N6952A-02

Modification Recommended Service Note

N6952A – Advanced Power System, DC Power Supply, 40V, 25A, 1000W

The Problem – Charge Present on the AC terminal when unplugging the unit.

Figure 7

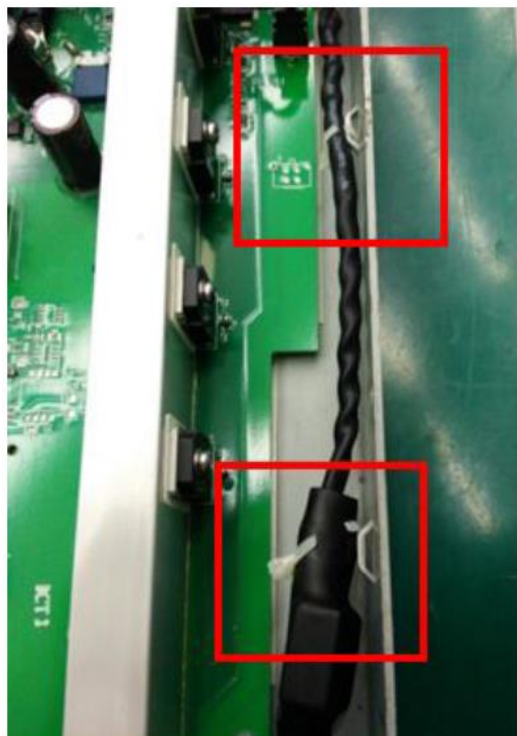
7. Cut 2 of the cable ties which secure the AC line cable as shown in Figure 7.

Figure 11

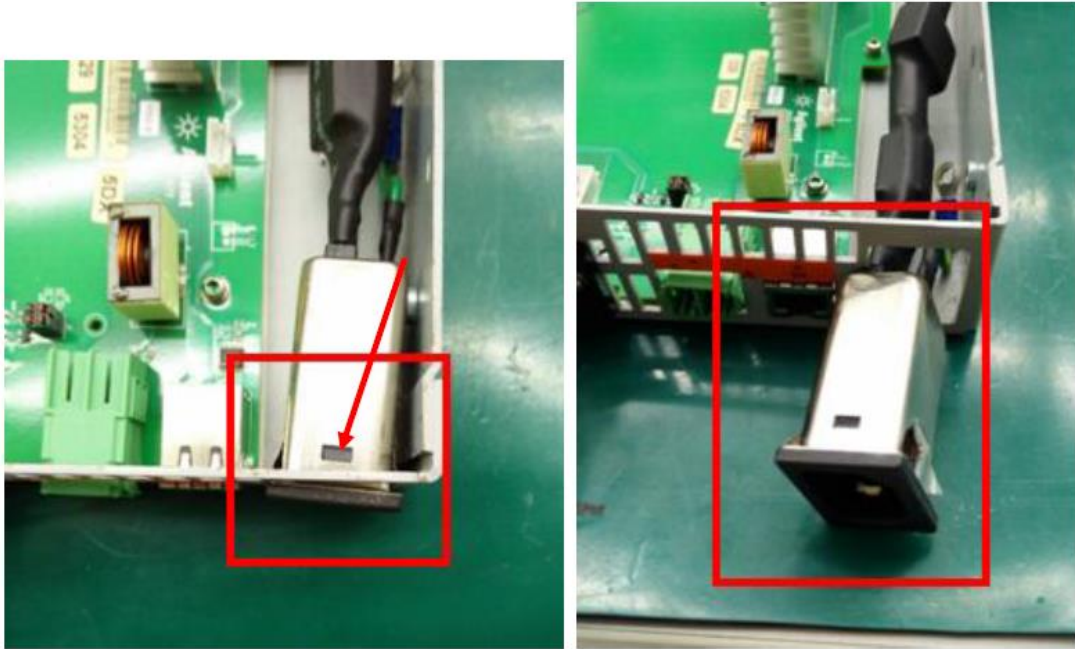
11. Remove AC line socket from chassis by pressing the lock chip as shown in **Figure 11**.

Figure 12

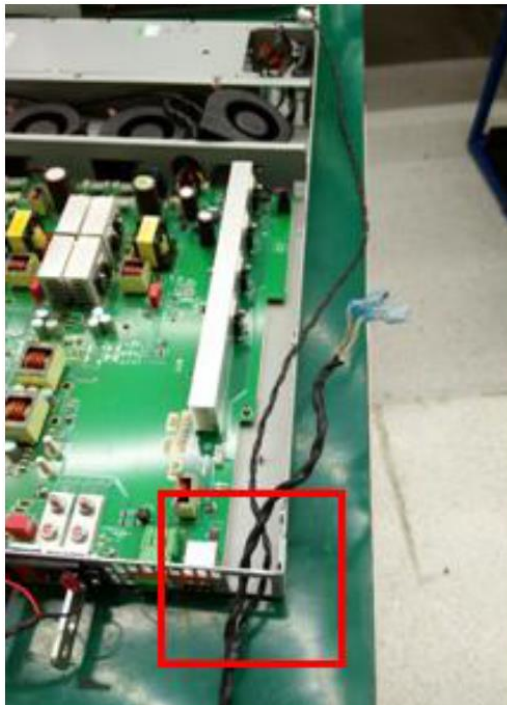
12. Insert the AC line cable (5190-4495) into chassis as shown in
13. Figure 12.

New AC line filter (5190-4495) with 15GENG3E-R is used to replace the existing AC line filter to optimize the discharge time.

Figure 14

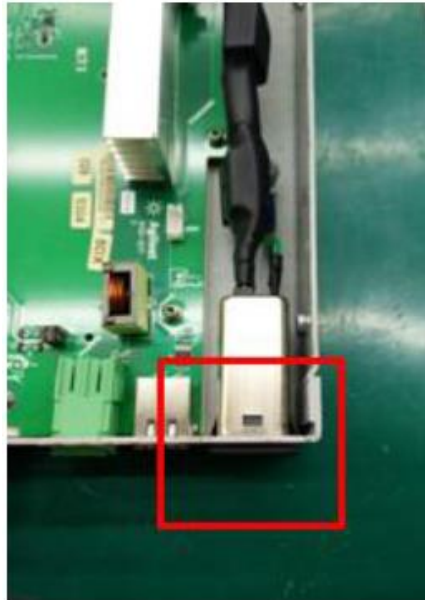
15. Press in AC line socket onto chassis as shown in Figure 14.

Figure 15

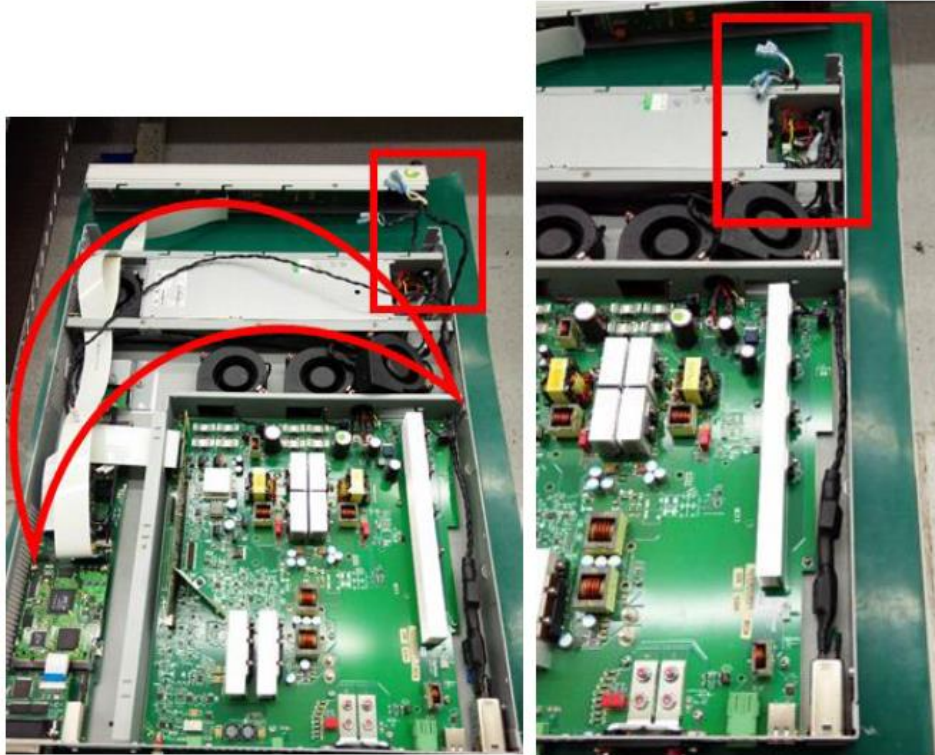
16. Route AC line through chassis hole until front panel. Another AC line cable will be insert into constellation PCA as shown Figure 15.

Figure 16

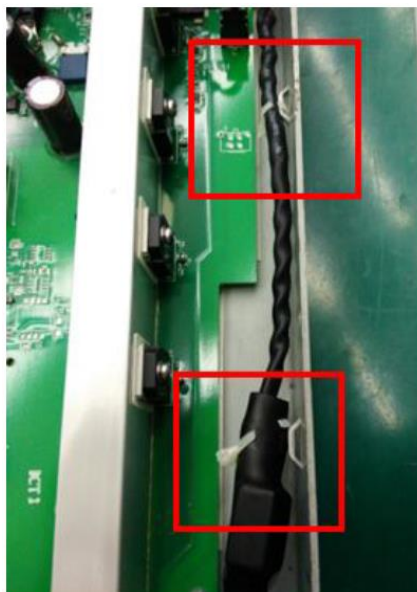
17. Insert 2 cable ties (1400-3204) to secure the AC line cable as shown in Figure 16.
